Groundwater Application Review Summary Form

Application # G- G-19043

GW Reviewer Gerald H. Grondin Date Review Completed: 11/19/2021

Groundwater Permit Application G-19043 Colahan Enterprises Inc. / Erin Douglas

Hydrograph of Water-Level Measurements in Vicinity Wells

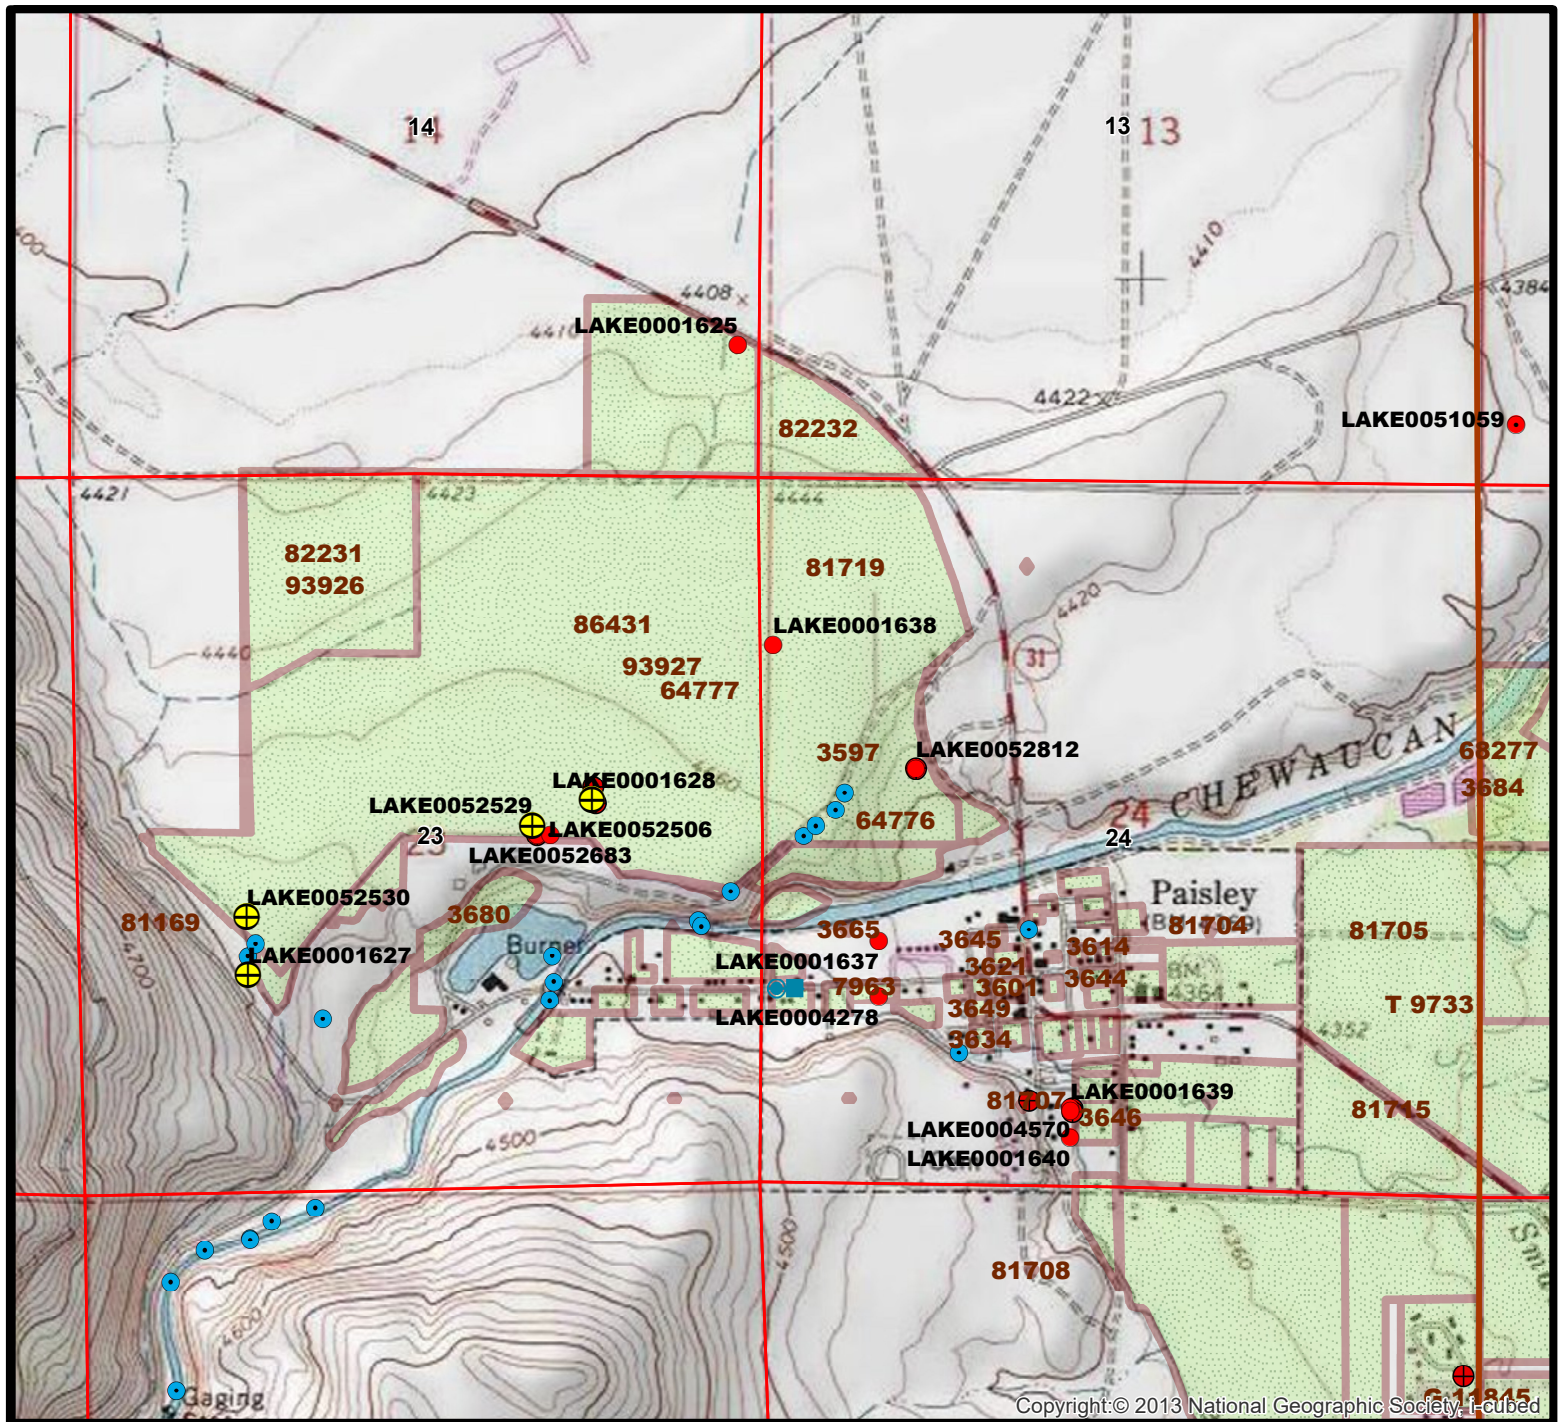
The groundwater levels at the proposed POD wells are more than 60 feet higher than the groundwater levels at wells east of Highway 31 (see attached hydrograph) and more than 40 higher than the groundwater levels at Paisley. The attached hydrograph does not show a groundwater level decline at the proposed POD wells, but a comparison of driller measurements to 2014 watermaster measurements indicates a possible decline (perhaps 20-feet) between older well construction and 2014 (see attached table). Longer term data is needed to determine the groundwater level trend at the POD wells. A groundwater level decline is occurring at the wells east of Highway 31.

LAKE 1628 to Chewaucan River

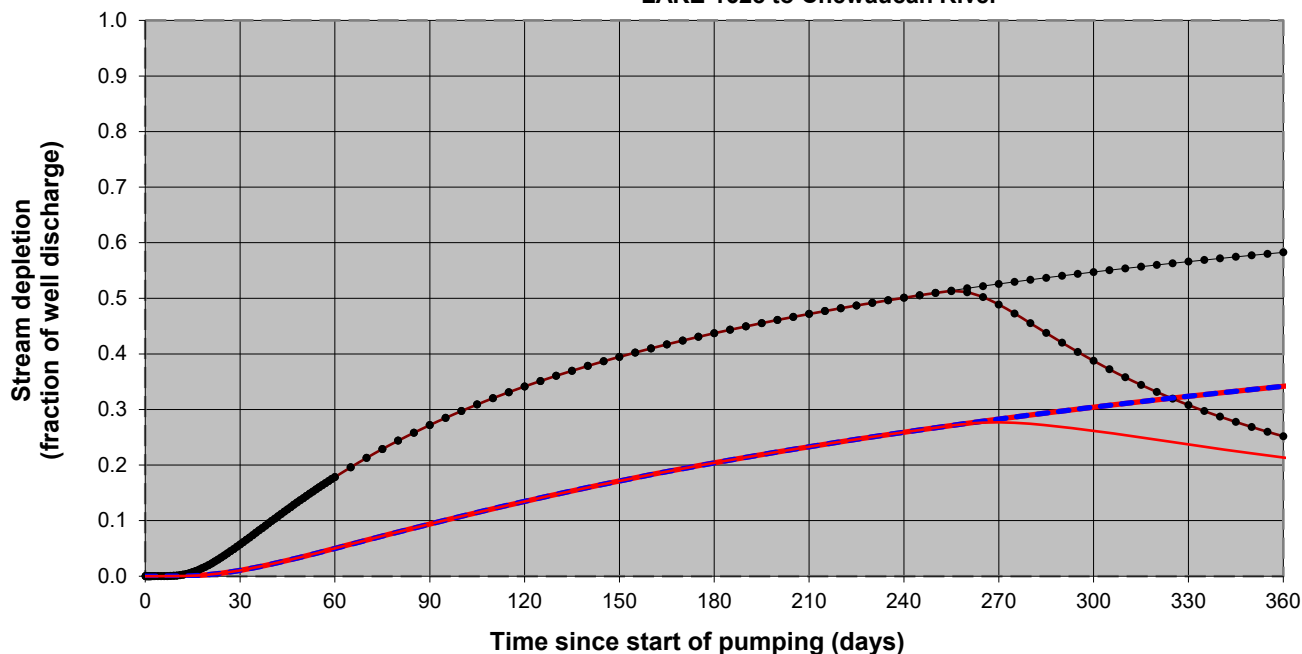
Well LAKE 1628/1626/52582 (Little Hot) is the only proposed POD well within one-mile of the estimated groundwater level-river level intercept. Hunt (1999) was used to calculate groundwater interference with surface water given the POD well obtains groundwater from the predominantly basin-fill unit which is in direct contact with the river. The calculation used the full rate requested (1.66 cfs) given the application appears to request being able to use up to 1.66 cfs at any combination of POD wells including a single POD well. The calculation used an average basin fill transmissivity of 115 ft²/day for the predominantly basin fill (see attached transmissivity calculation summary) and an intermediate storage coefficient of 0.001. The results do not trigger a potential for substantial interference assumption.

LAKE 52529 to Chewaucan River

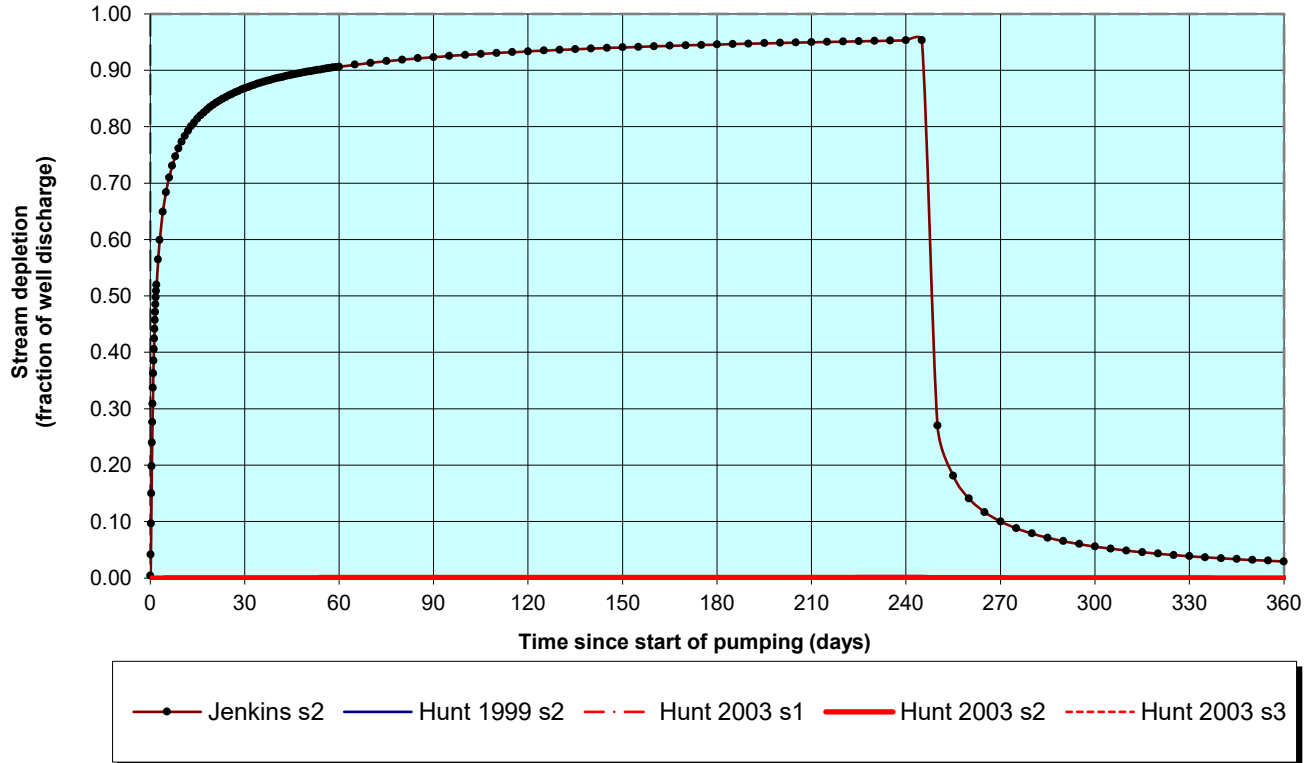
Wells LAKE 1627/4448 (Well #1), LAKE 52530/52866 (SVE #1), and LAKE 52529/52865 (SVE #2) are more than one-mile from the estimated groundwater level-river level intercept. Hunt (2003) was used to calculate groundwater interference with surface water given the POD wells obtain groundwater from the predominantly volcanic rock and sediment unit which is hydraulically connected to the river through the overlying predominantly basin-fill unit. The calculation used the full rate requested (1.66 cfs) at the closest well (LAKE 52529) given the application appears to request being able to use up to 1.66 cfs at any combination of POD wells including a single POD well. Additionally, the calculation represents the maximum possible interference. The calculation used an average basin fill transmissivity of 18,000 ft²/day for the predominantly volcanic rock and sediment unit (see attached transmissivity calculation summary) and an intermediate storage coefficient of 0.001. The results do not exceed one percent of the natural river flow for any month.
